RE: Valley Village MHP VARIANCE REQUEST

Ottumwa, Iowa Iowa Department of Natural Resources

15. Description of Variance Request

Re: Construction Permit Application
Wastewater Disinfection System
Valley Village Mobile Home Park
Ottumwa, Iowa
G & A 3098293

CHLORINE CONTACT TANK SCHEMATICS

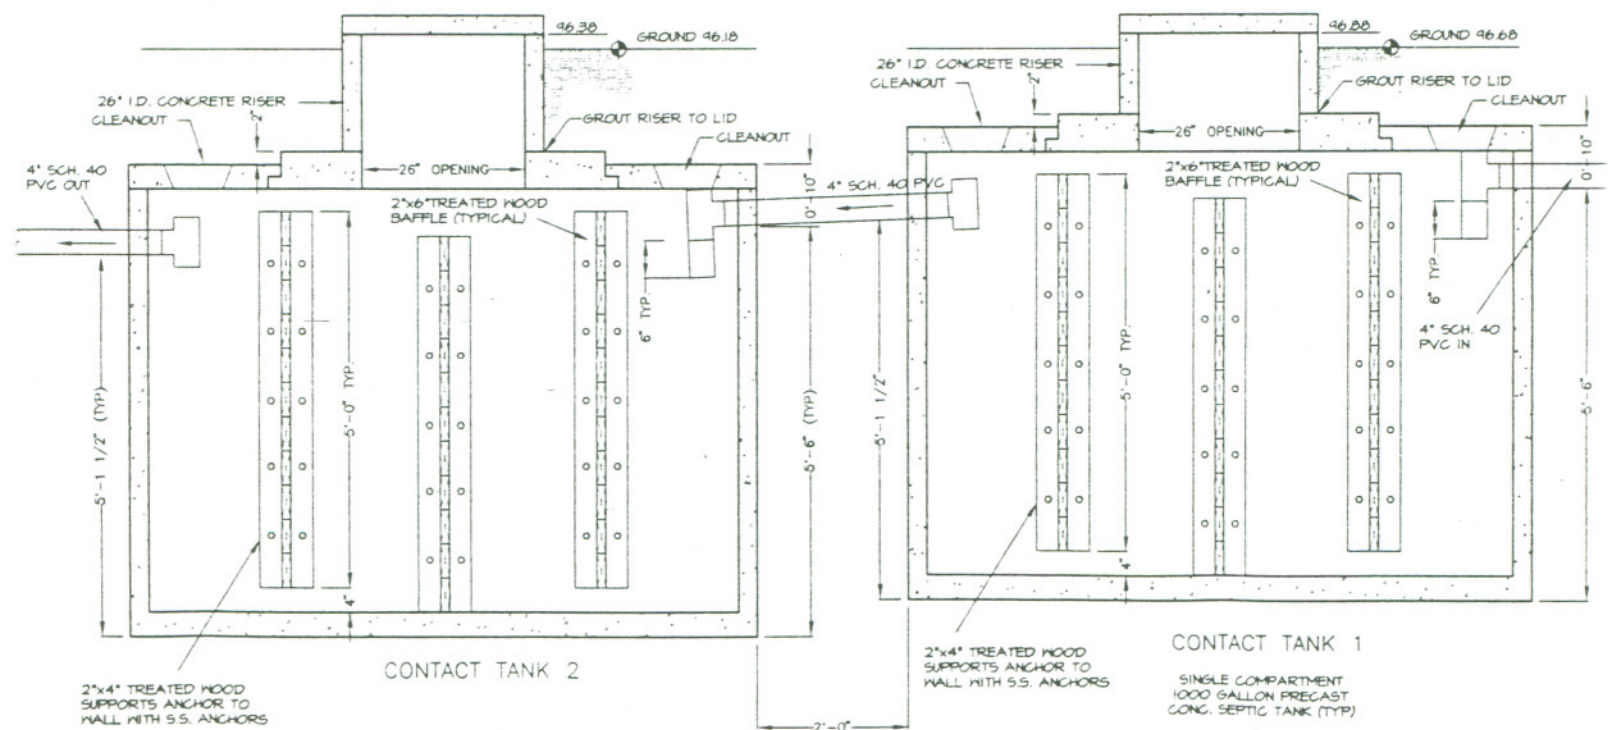
The consulting engineer has requested a variance to design a chlorine contact tank for the Valley Village MHP with approximately a 24 to 1 length to width ratio in lieu of the 40 to 1 length to width ratio required by Section 20.8.3 of the Iowa Wastewater Facilities Design Standards.

Please note we are also requesting a variance from Section 20.8.3 of the Iowa Wastewater Facilities Design Standards. As designed the contact tanks provide a length-to-width ratio of about 24:1 instead of the 40:1 required. It is our opinion the contact tanks as designed will reduce short-circuiting of flow to a practical minimum and result in adequate disinfection of the effluent. A tank(s) with a 40:1 length-to-width ratio was not designed for the following reasons:

1. Because the system operates at relatively small flows, it would be very difficult to construct a cast-in-place tank with a volume of only 2,000 gallons and a 40:1 length-to-width ratio. Therefore, the precast concrete septic tanks were used resulting in much easier construction and lower projects costs.

2. Effluent flows out of the treatment system are normally less than the 66 gpm, 1 pump capacity of the lift station because of the equalizing action of the polishing tank located prior to the contact tanks. This results in additional detention and treatment time in the contact tanks. To achieve a 66 gpm out of the system, the level of the 60' x 60' x 8' deep polishing tank will need to be raised about 2 inches or 4,500 gallons. The lift station pump would need to operate continuously for more than 68 minutes to transport 4,500 gpm to the polishing tank. This situation would be unlikely based on the population served and the past reported daily flows. Recently while calibrating the lift station pumps, flows to the lift station averaged 22 gpm.

By issuance of this construction permit Number 99-361-S we are hereby granting a variance for a length to width ratio for the chlorine contact tanks which is less than the 40 to 1 length to width ratio required under Section 20.8.3 of our design standards.

It is recommended that the variance request to design for a 24 to 1 length to width ratio be approved based upon the engineer's justification and the following additional considerations

- 1. The existing polishing tank has a detention time of 5+ days for the design AWW flow of 36,000 GPD. In addition to providing a throttling affect on wastewater flows, some natural die off of fecal coliform organisms should occur in the open polishing tank.*
- 2. Even if the flows thru the chlorine contact tanks should reach the pump capacity of 66 gpm, the detention time in the tanks would be double the minimum 15 minute detention time required in the design standard.*
